To: Aldridge, Steven <SAldridge@worcestershire.gov.uk> Subject:RE: Lea Castle Quarry Queries

Red = bat roost confirmed Blue = veteran tree

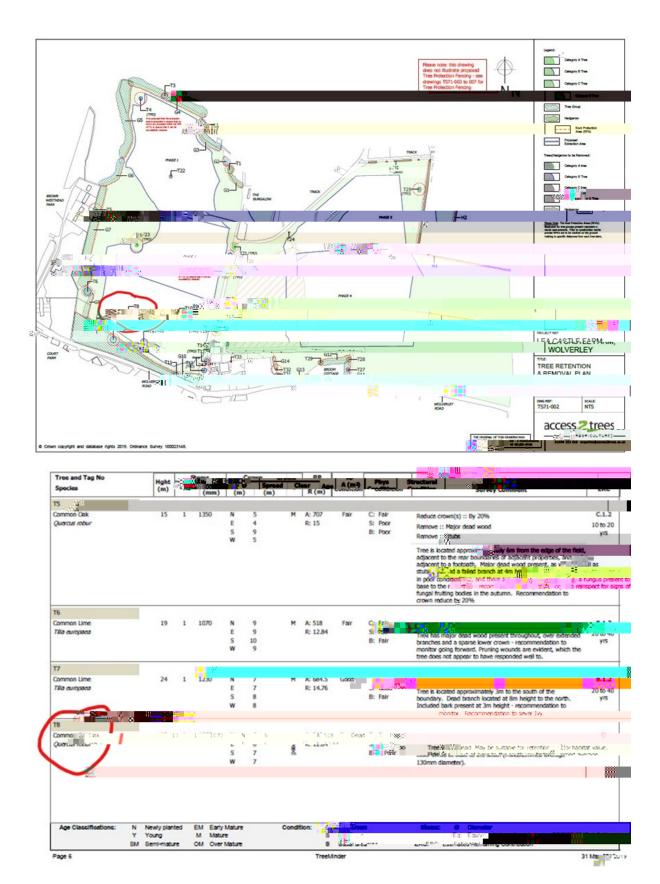
Sorry, you're quite right, there seems be a confusing mismatch in tree ID between the various

I think my point applies regardless of species and bat roost: development resulting in loss or deterioration of veteran treesT(5, T22andT25as per arboricultural report, based on combined assessment btwn the applicant's ecologists and arboriculturists) shouldn't be permitted unless there are wholly exceptional reasons and an acceptable compensation strategy exists.
